## ***Interactive comment on “Spatio-temporal trends in the hydroclimate of Turkey for the last decades based on two reanalysis datasets” by Mustafa Gokmen***

Anonymous Referee #3 Received and published: 19 March 2016

**Fig. 1.** The comparison of the (a) presence of the significant Air Temperature trends and (b) the magnitudes of 32-years total Air Temperature trends between the ERA-I dataset and the meteo-stations

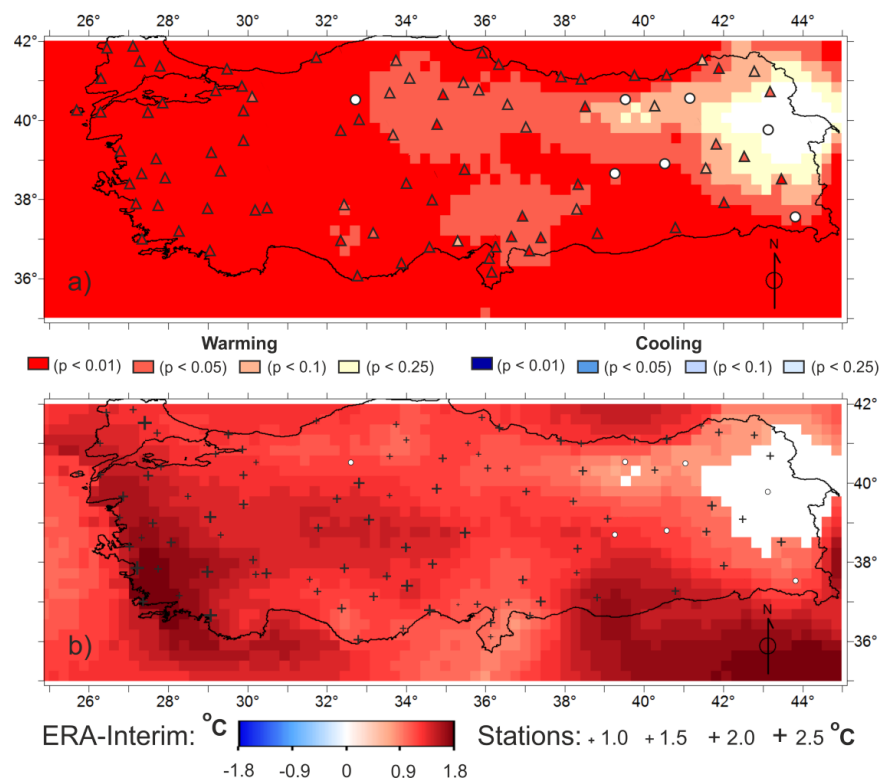
2. The discussion is not deep enough. The author may explain the trends of the variables based on physics for instance. Are those trends of the variables reasonable? Is the phenomenon in Turkey unique? Is there any suggestion? For example, Figure 3b shows the distribution and the histogram of the average temperature increases (over study period) with respect to elevation. Why? Please discuss. I would suggest the

Reply of the Author (2): First of all, thanks to the additional temperature data provided by Dr. Faize Saris from Canakkale 18 Mart University, the comparison could be extended to around 100 stations distributed over the country. The revised Figure (attached Fig1) presents an overlaid comparison of the significance and magnitude of the temperature trends by the ERA-Interim and meteo-stations. With the availability of more stations data, Figure 3 (in the manuscript) was also revised to compare the observational and reanalysis data in a more systematic manner. In the revised Figure (attached Fig.2), the average yearly temperature of all stations was compared to the yearly average reanalysis data at the same station locations for the study period.

Similar to the previous Figure 3b, the revised Figure also indicate that the total temperature increase during the study period is higher in the lowlands and lower in the higher altitudes by both ERA-Interim and meteo-stations. As it can be seen in the topography map in Figure 1 (in the manuscript), East/North East part of Turkey constitute the mountainous and higher elevation region, where the increasing trend of temperature was less or non-significant. The average height corresponding to this area is about 1850 m.a.s.l. (the average of whole country is 1140 m). Therefore, the region has relatively intense terrestrial climate with shorter summers and longer & harsher winters. As shown in the satellite image (attached Fig.3), the snow also stays longer on the land. Considering that there has not been considerable change in the snow dynamics for the very Eastern region during the study period (Figures 6a and 6b in the manuscript), albedo effect could play a role for relatively less amount of increase in the temperature. Besides, the Eastern region has also significantly less population density in the country, with even considerable population migration to the other regions. So direct urban/land use change contribution to the temperature increase can be less effective. Lastly, the differences in the regional climate system due to the different controlling factors (e.g. the differences in the effective pressure systems, topography, etc) can play a role.

**Fig. 4.** The presence and the direction of Total Precipitation trends by ERA-Interim for a) Winter, b) Spring, c) Summer and d) Autumn

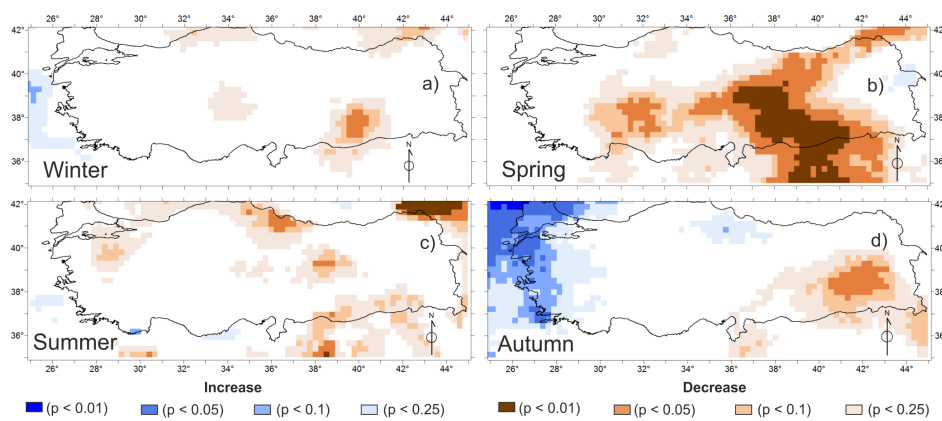
3. As pointed out by the Anonymous Referee #1 and # 2, the seasonal variations should be considered since it may strongly affects the intra-annual trends.

Reply of the Author (3): As suggested by the Reviewer #3 (and Reviewers #1, #2), the spatio-temporal trends in precipitation were analyzed at seasonal scale and the results will be included in the revised manuscript.

**Fig. 9.** Fig9a The distribution of the average P ET ratio during the study period (1979-2010)

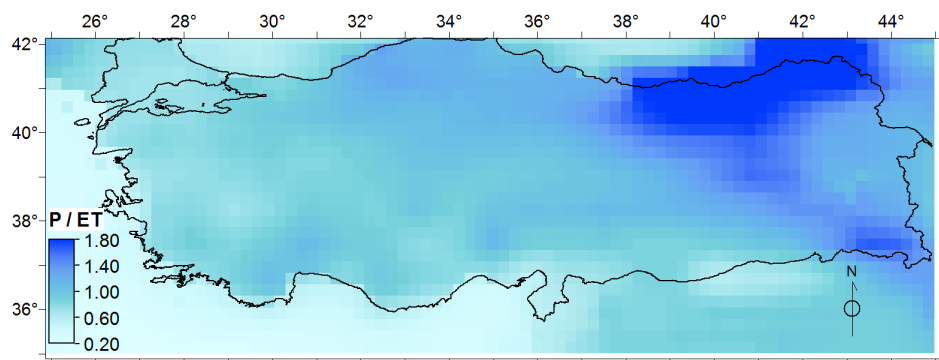
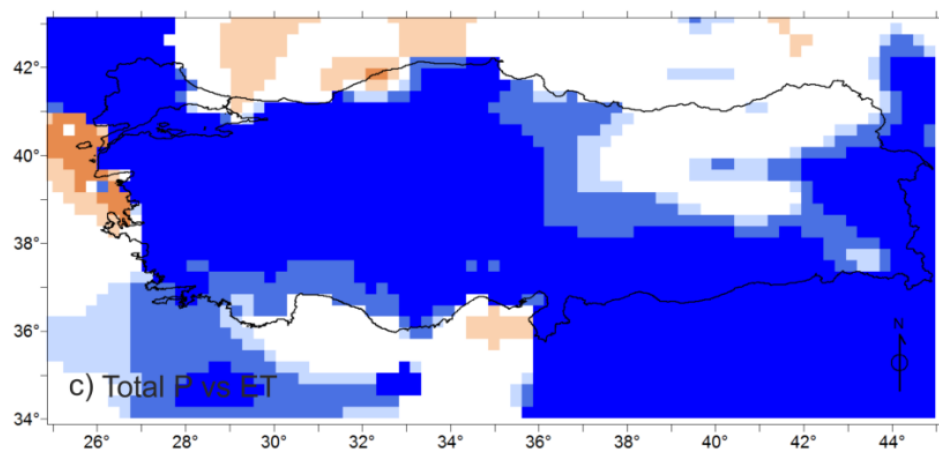
4. The author stated “while over land, ET is mainly water-limited (i.e. precipitation and soil moisture) especially for semiarid regions. ” This statement is not right since, in some humid regions, ET is energy-limited and there are many humid regions over land. For more information, please see the article “Seneviratne, S. I., T. Corti, E. L. Davin, M. Hirschi, E. B. Jaeger, I. Lehner, B. Orlowsky, and A. J. Teuling (2010), Investigating soil moisture–climate interactions in a changing climate: A review, *Earth-Science Reviews*, 99(3–4), 125–161.”

: over sea, ET is generally energy-limited (i.e. temperature and incoming radiation), while over land, ET is mainly water-limited (i.e. precipitation and soil moisture) in semi-arid regions and energy-limited in humid regions.

To support the statement, (attached) Figure9 shows the long term average of the P/ET ratio and the correlation between P and ET for the region. As clearly shown in P/ET ratio map, except for the humid North-East region by the Black Sea, most of the study area has relatively semi-arid conditions with P/ET ratio less than 1. As a result, the correlation map reveals that, for non-humid parts of the country, there is a strong positive correlation between the Precipitation and ET, implying ET is mainly precipitation-controlled in these areas.
